ITEM: 6.7	REPORT SUMMARY MINOR VARIANCE APPLICATION FILE NUMBER A049/24
------------------	--

MINOR VARIANCE APPLICATION FILE NUMBER A049/24

CITY WARD #:	2
APPLICANT:	Augusto & Pearl Ceron
AGENT:	Kelvin Lo & Salik Imtiaz
PROPERTY:	70 Condotti Drive, Woodbridge
ZONING DESIGNATION:	See below.
VAUGHAN OFFICIAL PLAN (2010) DESIGNATION:	Vaughan Official Plan 2010 ('VOP 2010'): "Low-Rise Residential"
RELATED DEVELOPMENT APPLICATIONS:	None
PROPOSAL:	Relief from the Zoning By-law is being requested to permit a proposed pergola in the rear yard.

PROPOSED REAR YARD PERGOLA
70 CONDOTTI DR
WOODBRIIDGE, ON L4H 0H6

1 SITE PLAN
1 : 200

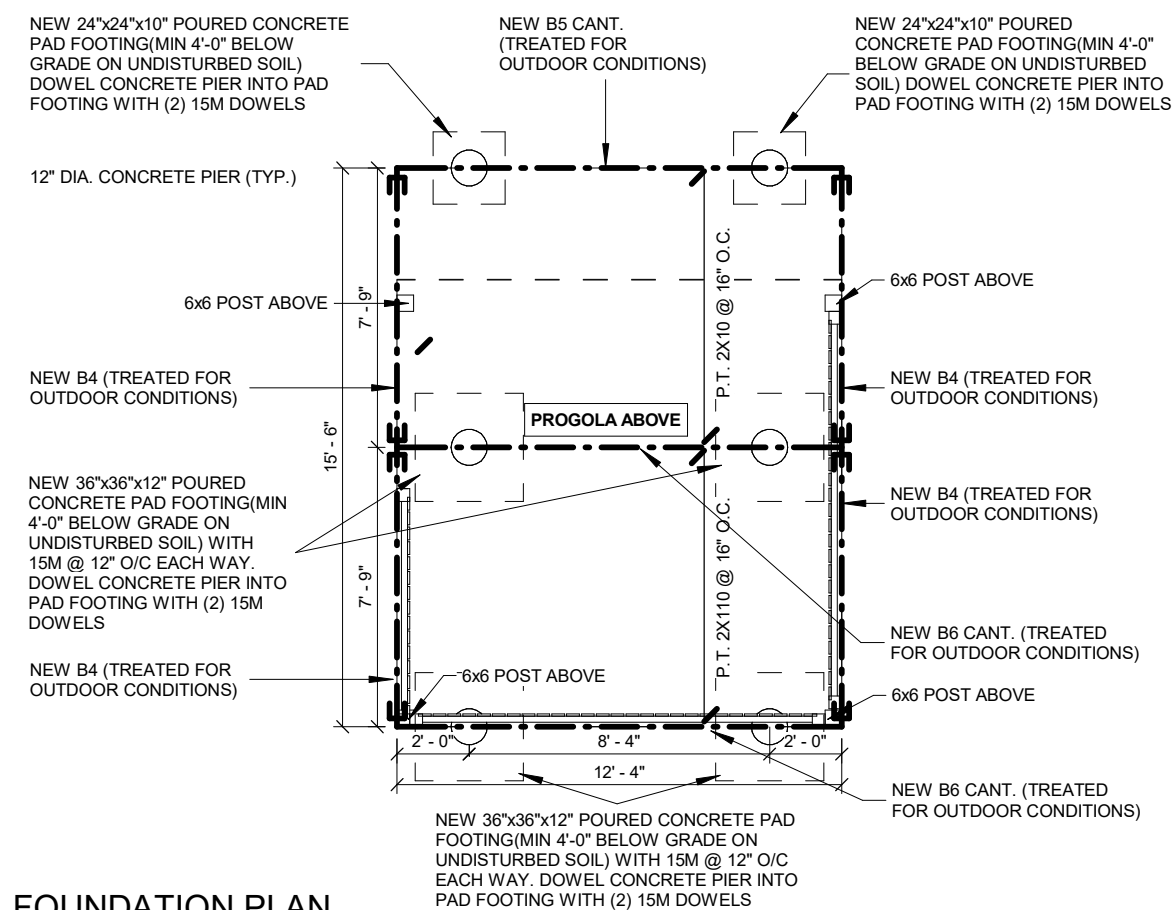
Zoning By-law 01-2021	
1	The existing shed abutting the existing deck appears to comply, as it is less than 2.8 m in height and a minimum of 1.2 from the interior side lot line.
2	The existing shed directly abutting the fence does not comply. As it appears to be less than 2.8 m in height, it would require a minimum of 0.6 m setback from the fence. It should either be moved to comply with the required minimum setback of 0.6 m from the interior side lot line, or removed all together. The applicant has indicated the Shed will be moved to comply with the minimum 0.6 m interior side yard setback.

The Owners are requesting relief to permit an existing accessory structure (gazebo), labeled as 'new pergola' on the submitted sketch, located within the north-west corner of the rear yard with the above-noted variances.

Development Planning Department Staff ('Development Planning Staff') have no objection to the request to permit a reduced interior side yard setback measured to the two west posts (Variance 1) and to the eaves of the gazebo (Variance 3), as well as a reduced rear yard setback measured to the two rear posts (Variance 2). The accessory structure exists in the north-west corner of the rear yard. The north and west sides of the gazebo are screened with wood lattice while the other two sides are open. The gazebo is modest in size does not exceed the maximum lot coverage and maximum height requirements of the Zoning By-law for accessory buildings and structures. The rear of the gazebo faces the interior side yard of the property to the north, 12 Massimo Drive, which maintains a utilitarian rather than yard amenity area.

As such, the gazebo is not anticipated to have adverse use (privacy) or massing impacts on the neighbouring property to the west (66 Condotti Drive) or the property to the north (12 Massimo Drive), and the proposed 0.79 m minimum interior side yard setback provides sufficient space for safe maintenance and access purposes.
